Luminant

SUBJECT: COMANCHE PEAK STEAM ELECTRIC STATION (CPSES)
DOCKET NOS. 50-445 AND 50-446
RESPONSE TO REQUEST FOR ADDITIONAL INFORMATION REGARDING LICENSE AMENDMENT REQUEST 09-007, MODEL D5 STEAM GENERATOR ALTERNATE REPAIR CRITERIA
(TAC NOS. ME1446 AND ME1447)

Westinghouse Letter LTR-SGMP-09-100-NP-Attachment
Response to NRC Request for Additional Information on H*
Model F and D5 Steam Generators
Non-Proprietary

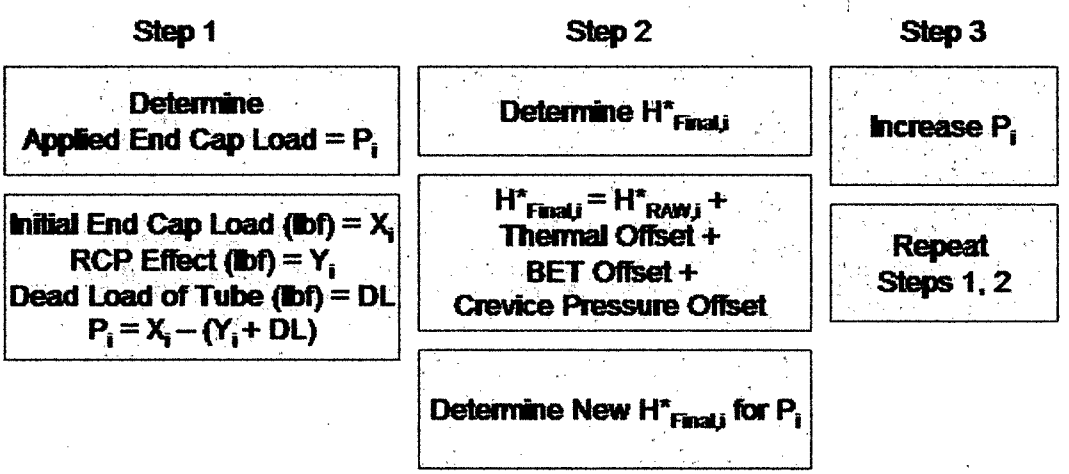
RAI	*Vogtle*	*20. Section 8 of Reference 1: The variability of H* with all relevant parameters is shown in Figure 8-3. The interaction between α_T and α_{TS} are shown in Figure 8-5. Please explain why the direct relationships shown in these two figures were not sampled directly in the Monte Carlo analysis, instead of the sampling method that was chosen. Also, please explain why the sampling method chosen led to a more conservative analysis than directly sampling the relationships in Figures 8-3 and 8-5.*
	WCGS	*21. Section 8 of Reference 1: The variability of H* with all relevant parameters is shown in Figure 8-3. The interaction between α_T and α_{TS} are shown in Figure 8-5. Please explain why the direct relationships shown in these two figures were not sampled directly in the Monte Carlo analysis, instead of the sampling method that was chosen. Also, please explain why the sampling method chosen led to a more conservative analysis than directly sampling the relationships in Figures 8-3 and 8-5.*

A value of H* is determined for any value of RCL for the limiting SG operating condition at the limiting TS radius and sector in the bundle. The process for determining the H* value is shown in the following flow chart.

The result of this process is a surface of the response in H* to changes in RCL and α_{srss} the square root of the sum of squares of the specific variations in CTE from one MC simulation). If the values for RCL are normalized to an assumed value, say [ ]^{a,c,e} lbf, and the values of H* are taken as the change in H* relative to the value of H* with an RCL of zero, the result is a non-dimensional surface that can be used in conjunction with a Monte Carlo analysis to determine the reduction in H* due to the inclusion of RCL. Figure RAI20-9 is a surface plot of the change in the Model F H* values as a function of RCL and α_{srss}. Figure RAI20-10 is a surface plot of the change in the Model D5 H* values as a function of RCL and α_{srss}.
